Addendum #3

Date: April 5, 2024
From: Trevor Adaline, Procurement Strategist
To: Interested Bidders
Subject: Addendum #3 Solicitation #23-8194R – South County Regional Water Treatment Plant (SCRWTP) Filter Media Replacement and Blend Tank Passive Relief

COLLIER COUNTY
SCRWTP FILTER MEDIA REPLACEMENT
CIVIL
PIPING DETAILS

VERIFY SCALES	JOB NO. 201922
BAR IS ONE INCH ON ORIGINAL DRAWING	DRAWING NO. 00C02
IF NOT ONE INCH ON THIS SHEET, ADJUST SCALES ACCORDINGLY	SHEET NO. 7 OF 9

PASSIVE RELIEF PIPING DETAILS

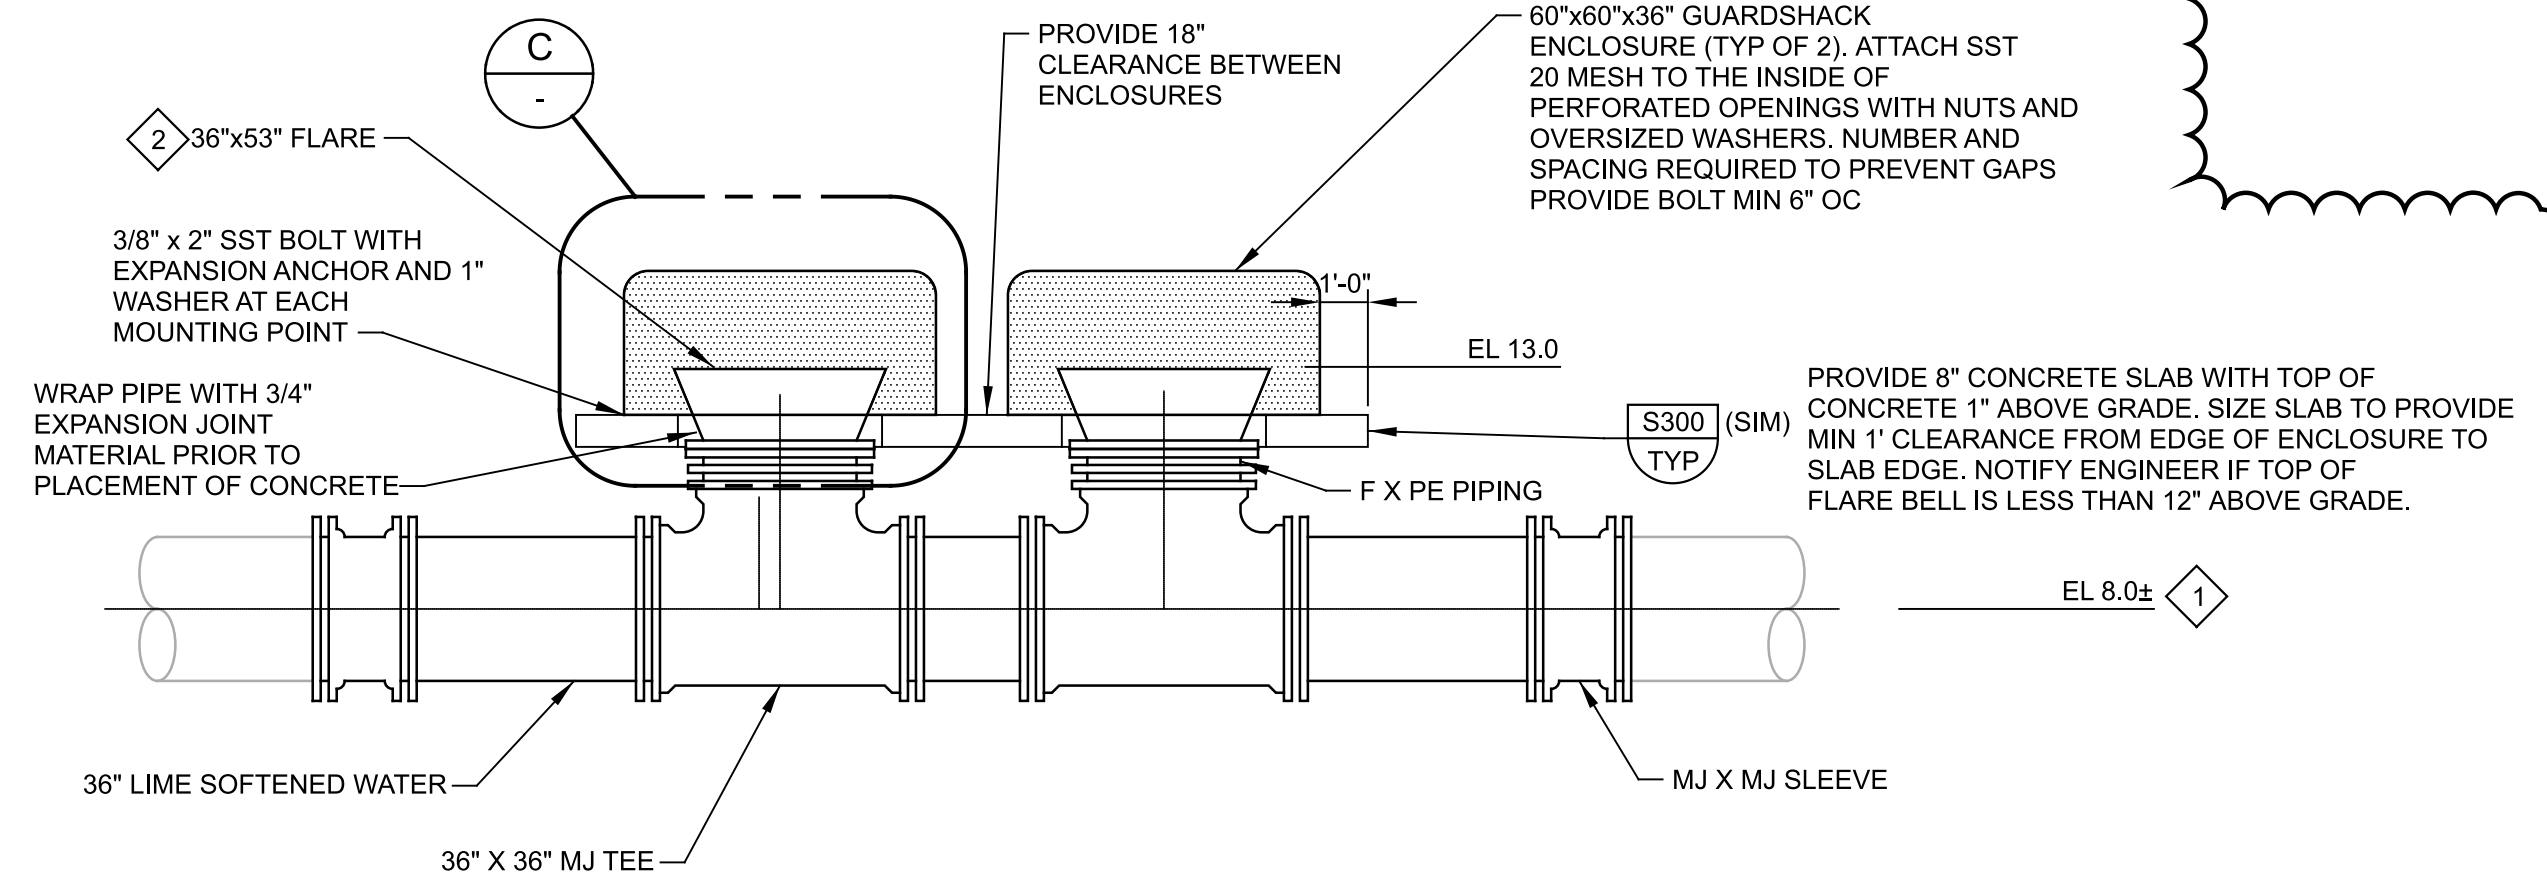
- 1.) Sheet 00C02 of the plans shows the existing pipe with a center elevation of 11.08. It also shows the top of flare elevation as 13.0. Is this correct?
- 2.) Sheet 00C02 shows an 8" concrete slab at the enclosure area with a callout detail of "S300". I don't see this detail in the plans. What are the dimensions of this slab?
- 3.) Please confirm that the \$100,000 owners allowance mentioned on the bid form shall not be included in our proposal.
- 4.) The schedule of values states that "mobilization plus demobilization shall not exceed 5 percent of the Contract Price". Does the contract price include the owner's allowance?
- 5.) The bid form calls for "Record Drawings" to be 6 EA. Shouldn't this be 1 LS, or do you want 6 sets of record drawings?
- 6.) Sheet 00C02 calls out the guardshack enclosure to be 60"x60"x36" however the details shows it being 24" tall. Which is correct?

- 1.) Please see revised drawing attached to this Addendum 3.
- 2.) Please see revised drawing attached to this Addendum 3.
- 3.) Owner's allowance is not included into total bid amount, but will be part of the contract.
- 4.) Owner's allowance is to not exceed 5 percent of the Total Bid Amount as revised in bid schedule. The owner's allowance will be viewed as part of the contract, but not the total bid amount.
- 5.) The intent is to have the contractor submit redlines at the completion of each filter showing any changes. This will allow for 6 partial payments.
- 6.) Please see revised drawing attached to this Addendum 3.
